No. 426-3

## APPLICATION FOR/PERMIT

## Lake Mitchell Dam Variance Request

Figure 1: Overview of Lake Mitchell Dam

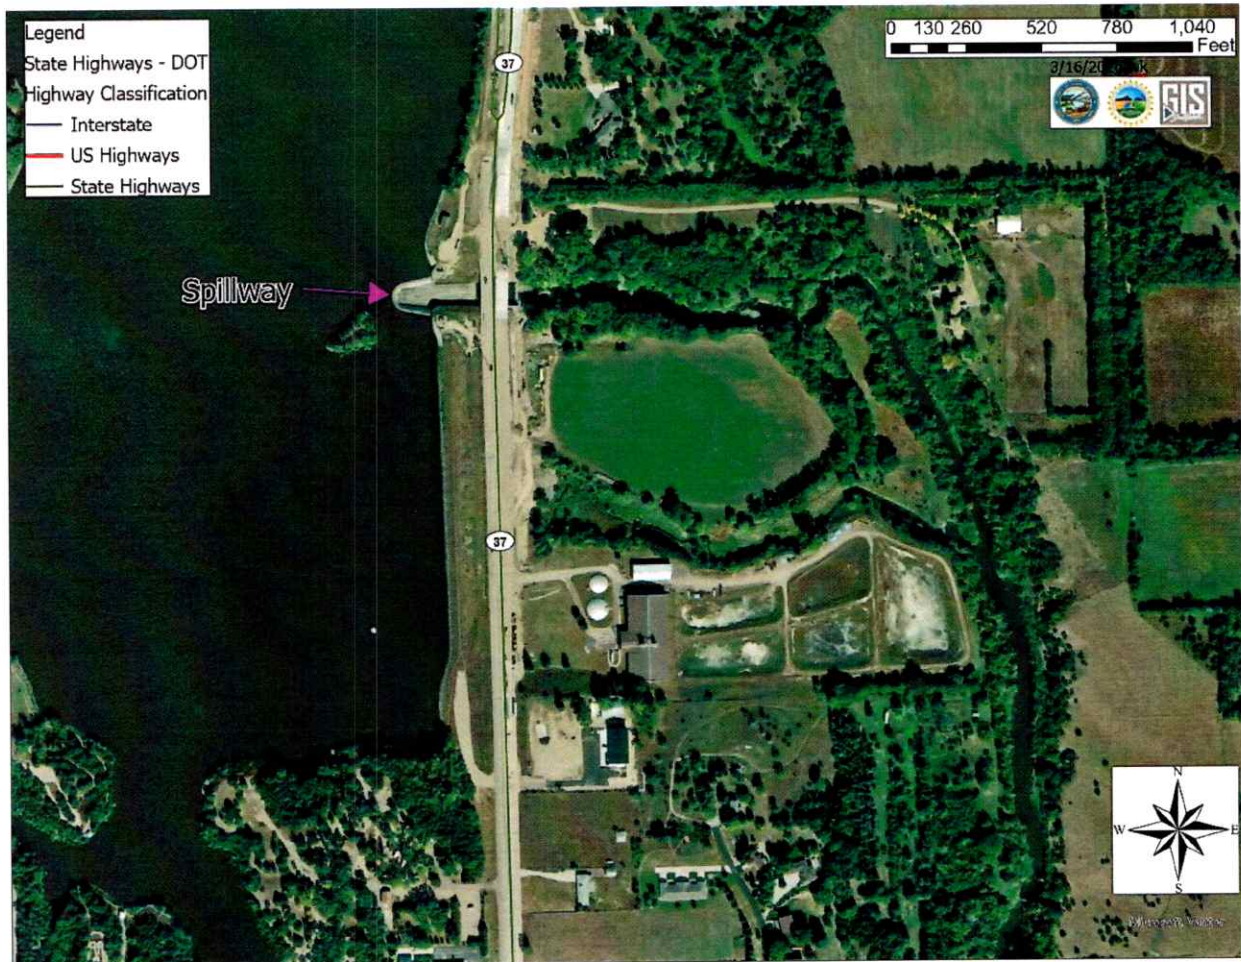
There have been two past studies of the 0.5 PMF (also commonly called the 50% PMF) for Lake Mitchell. Lake Mitchell has a concrete horseshoe weir structure serving as the dam's only spillway structure to pass water through the dam. An overview of the dam is provided in Figure 1.

Figure 2: USBR (1988) depth-velocity-flood danger relationship for houses built on foundations

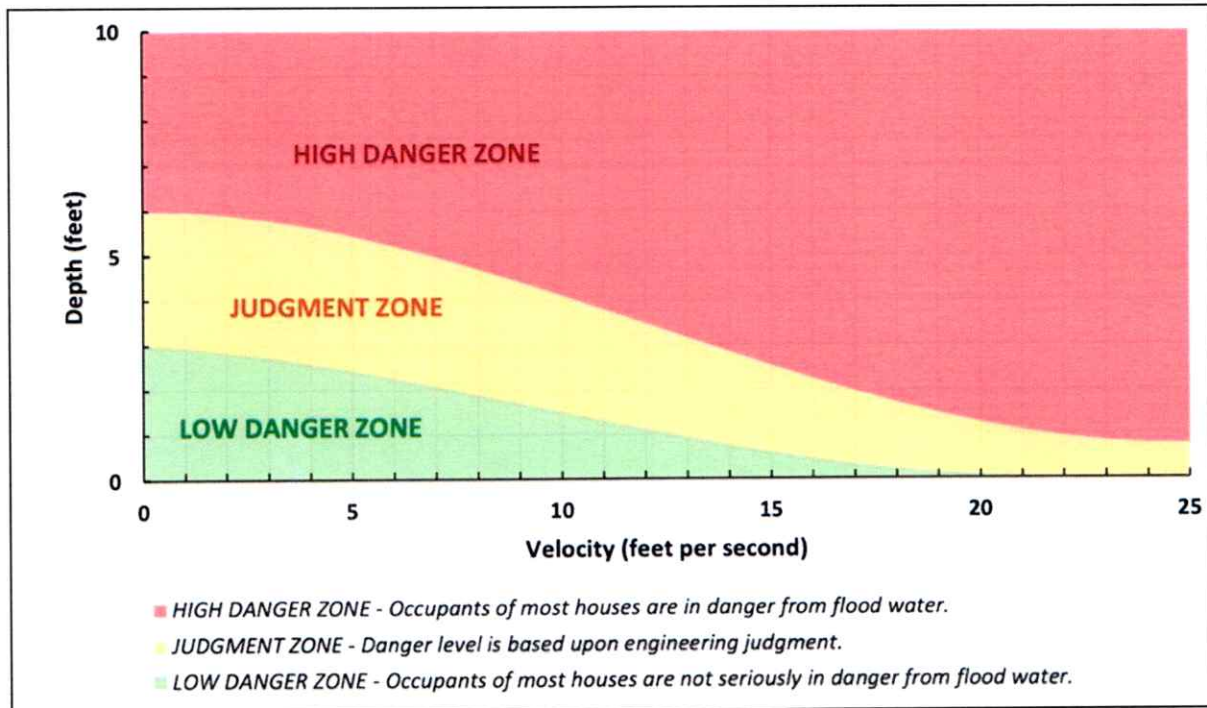
The two major factors for looking at a flood risk to habitable structures are the depth of flood waters and the velocity of flood waters. USBR (1988) sets danger zones for different depth velocity combinations for houses built on foundations, this is provided in Figure 2. Table 3 provides the danger zone for each structure at the 0.23 PMF event both with and without a dam breach. Table 3 shows the danger zone for each structure if the dam was upgraded to be able to

pass the 0.5 PMF event both with and without dam failure. The cost to rehabilitate/modify the dam to pass the 0.5 PMF event without failure would likely be in the millions of dollars, based on the cost of other recent dam rehabilitation projects in SD (Water Rights, 2026). However, in the the Finding of Facts and Conclusions of Law for the denial of the Fourth Street dam variance request by the City of Pierre the Board concluded, “The existence of collateral benefits to residents of the City and the lower costs to residents of the City from the grant of the variance are not factors which may be considered in the grant of the variance.” (Water Rights, 2026)
